**REMARKS**

The Official Action objects to the drawings as failing to comply with 37 CFR §1.84(p)(5). The Official Action draws specific reference to the reference numeral 39 in Figure 6, and reference numeral 42 in Figure 7, neither of which are identified in the specification.

Reproduced below is Figure 2 of the applied reference, modified only by shading the surface of the light intercepting mask 30. As is clear from this illustration, the opening defined by mask 30 is clearly not circular, contrary to the recitations of each of the present independent claims.

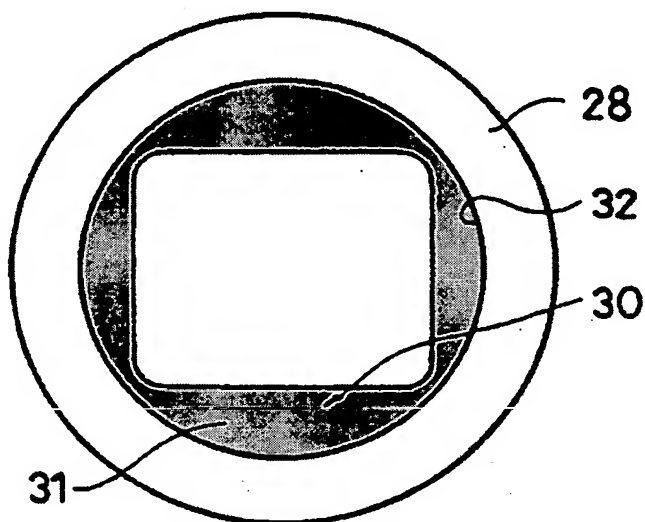
The Official Action identifies the various elements of the KOHMOTO et al. device construed as meeting the features recited by the rejected claims. Among these is the light intercepting mask 30 of KOHMOTO et al. considered to meet the recited flare stopper of the rejected claims. Among the features of the recited flare stopper is an inner periphery defining a circular opening.

Moreover, the non-circular shape of the opening in mask 30 of the reference is, as described on lines 61-62 of column 3, one of the most significant features of that device.

As a result, the KOHMOTO et al. patent cannot reasonably be construed as disclosing a flare stopper having an inner periphery defining a circular opening, nor can it be considered to disclose such inner periphery having the form of a side face of a circular truncated cone, both of which are recited in claim 1 as originally filed. Similarly, with respect to present independent claim 6, the KOHMOTO et al. patent clearly fails to disclose the circular opening of the flare stopper.
